JAMES A. FITZPATRICK NUCLEAR POWER PLANT

AMENDMENT TO FACILITY OPERATING LICENSE

Amendment No. 258
License No. DPR-59

ATTACHMENT TO LICENSE AMENDMENT NO. 258

Figure 3.6-1 Part 1 Reactor Vessel Pressure-Temperature Limits Through 24 EFPY

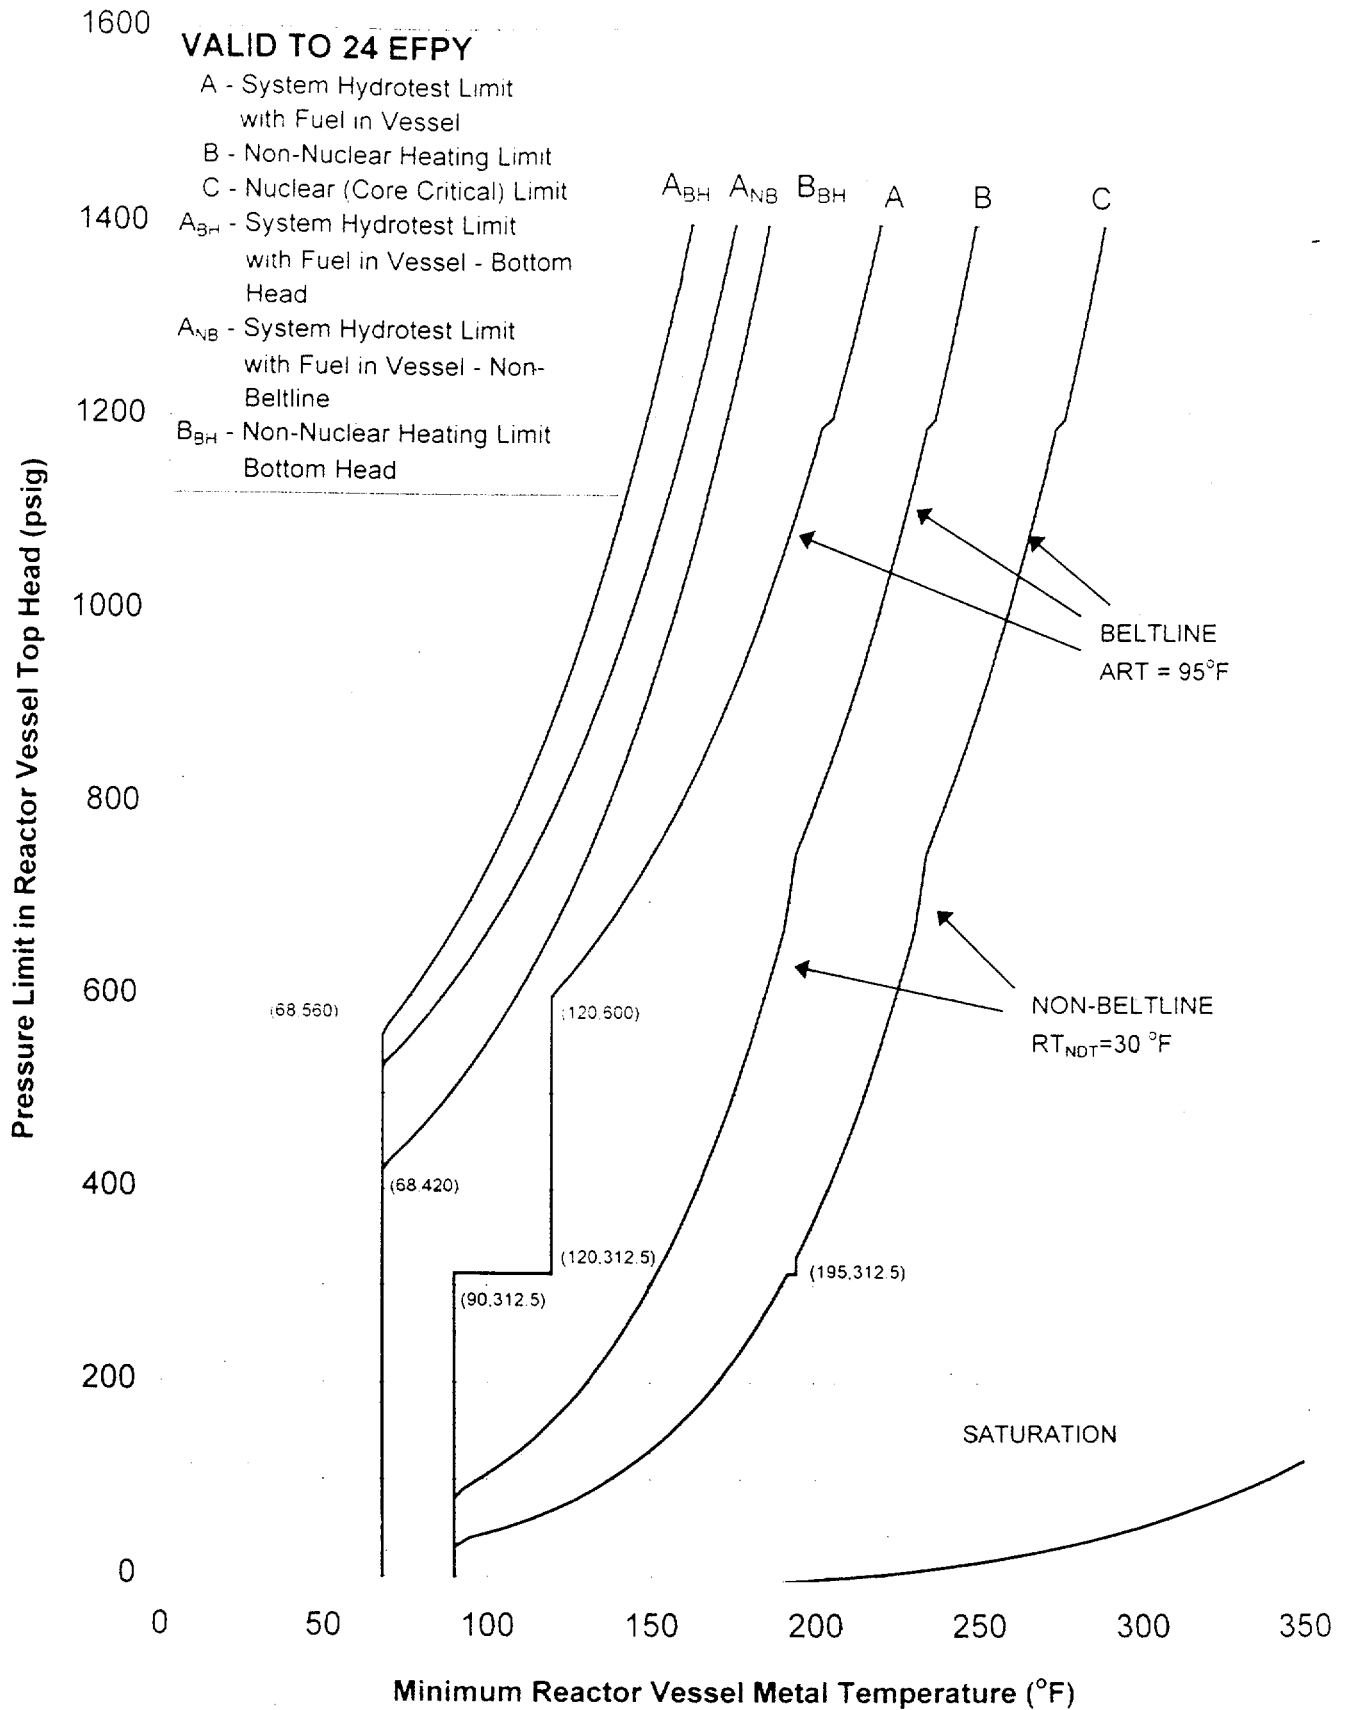
During in-service hydrostatic or leak testing the Reactor Coolant System pressure and temperature shall be on or to the right of curve A shown in Figure 3.6-1 Part 1 or 2 for the flange and the beltline region, and on or to the right of curve A_{NB} for the non-beltline regions, and on or to the right of curve A_{BH} for the bottom head region. The maximum temperature change during any one hour period shall be:

During heatup by non-nuclear means (mechanical), cooldown following nuclear shutdown and low power physics tests the Reactor Coolant System pressure and temperature shall be on or to the right of the curve B shown in Figure 3.6-1 Part 1 or 2 for the flange, upper vessel and beltline regions, and on or to the right of curve B_{BH} for the bottom head region. The maximum temperature change during any one hour shall be $\leq 100^{\circ}\text{F}$.

During all modes of operation with a critical core (except for low power physics tests) the Reactor Coolant System pressure and temperature shall be at or to the right of the curve C shown in Figure 3.6-1 Part 1 or 2. The maximum temperature change during any one hour shall be $\leq 100^{\circ}\text{F}$.

Figure 3.6-1 is comprised of two parts: Part 1 and Part 2. Part 1 establishes the pressure-temperature limits for the bottom head, flange, upper vessel and beltline regions for plant operations through 24 Effective Full Power Years (EFPY). Part 2 establishes the pressure-temperature limits for plant operations through 32 EFPY. The curves contained in Figure 3.6-1 are developed from the General Electric Report GE-NE-B1100732-01, Revision 1 (February 1998), including Errata and Addenda dated June 1999.

Figure 3.6-1 Part 2 Reactor Vessel Pressure-Temperature Limits Through 32 EFY

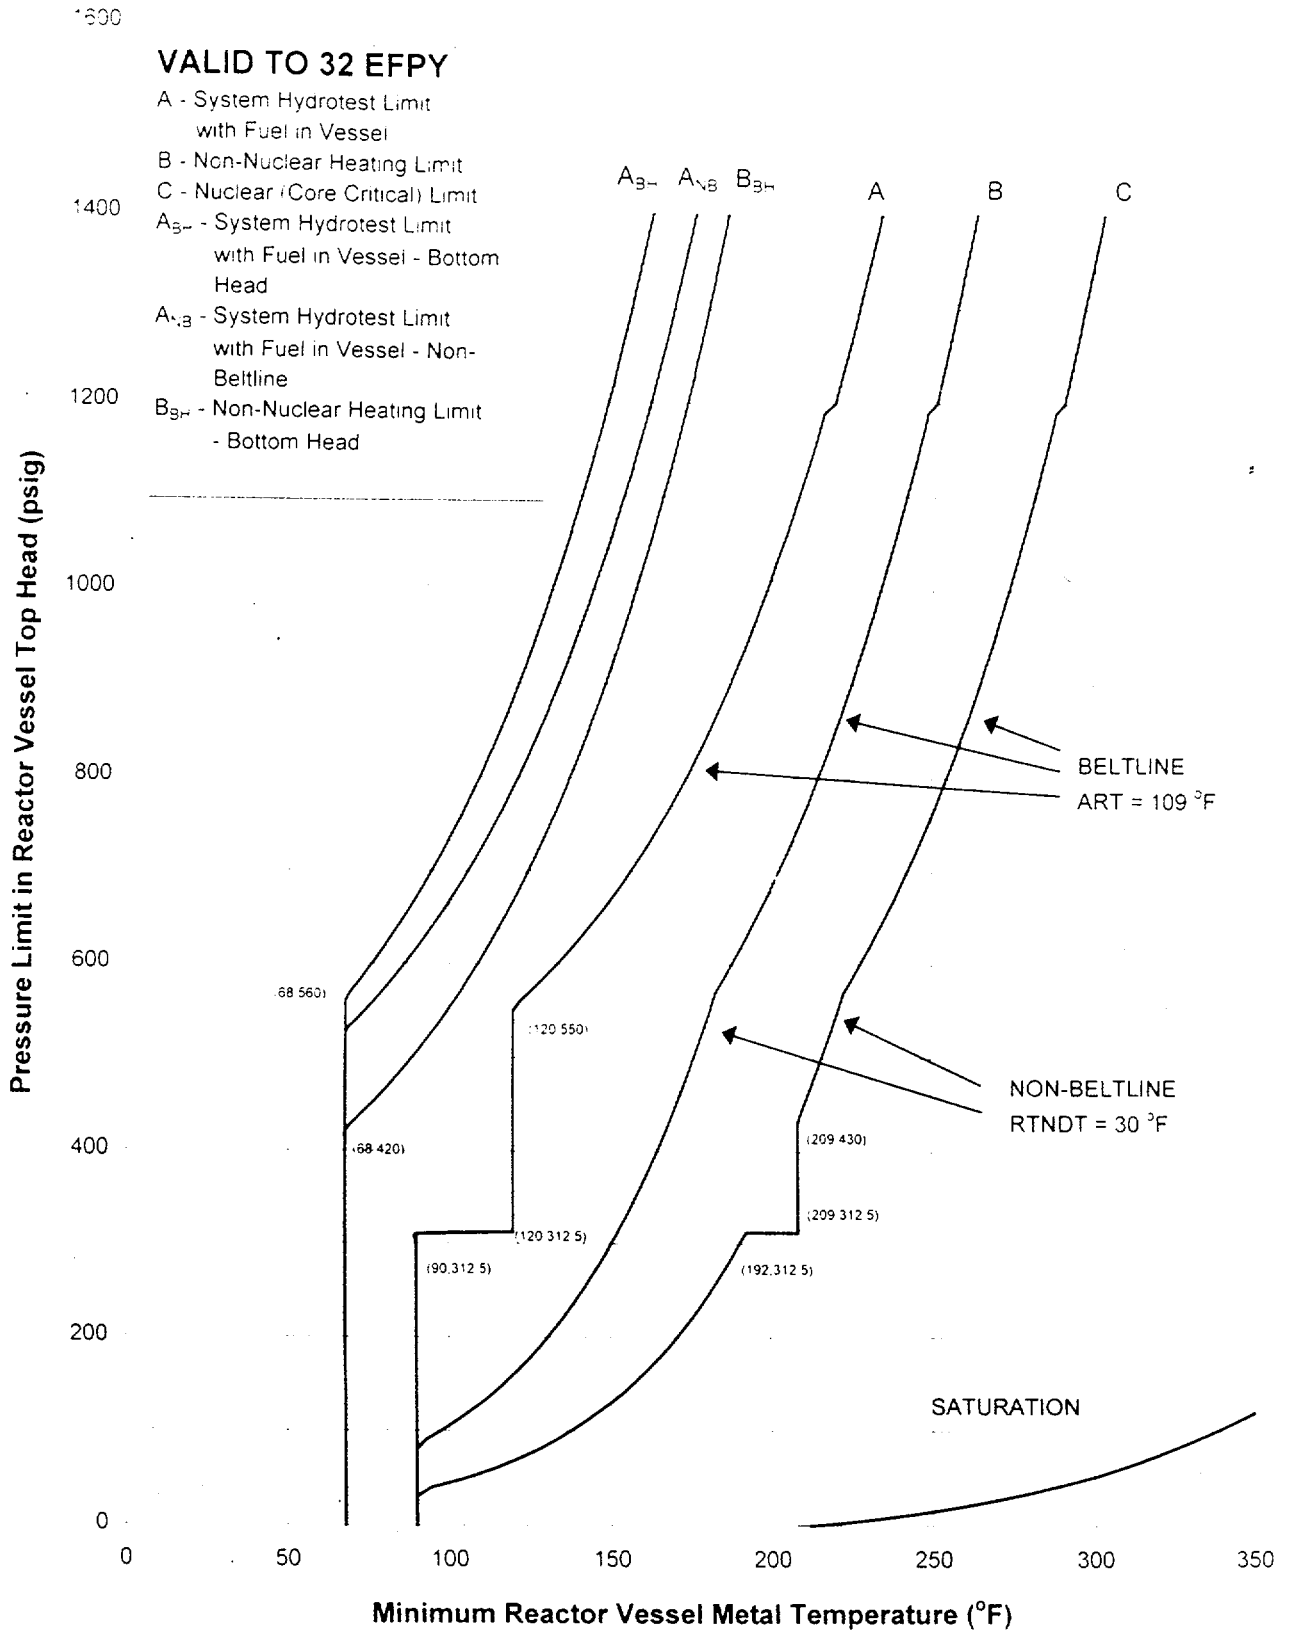
Figure 3.6-1 curves A, A_{BH} , and A_{NB} establish the minimum temperature for hydrostatic and leak testing required by the ASME Boiler and Pressure Vessel Code, Section XI. Test pressures for in-service hydrostatic and leak testing are a function of the testing temperature and the component material. Accordingly, the maximum hydrostatic test pressure will be 1.1 times the operating pressure or about 1,144 psig.

Fig. 3.6-1, curves B and B_{BH}, provide limitations for plant heatup and cooldown when the reactor is not critical or during low power physics tests. The thermal limitation is based on maximum heatup and cooldown rates of 100°F/hr in any one-hour period.

Fig. 3.6-1, curve C, establishes operating limits when core is critical. These limits include a margin of 40°F as required by 10 CFR 50 Appendix G.
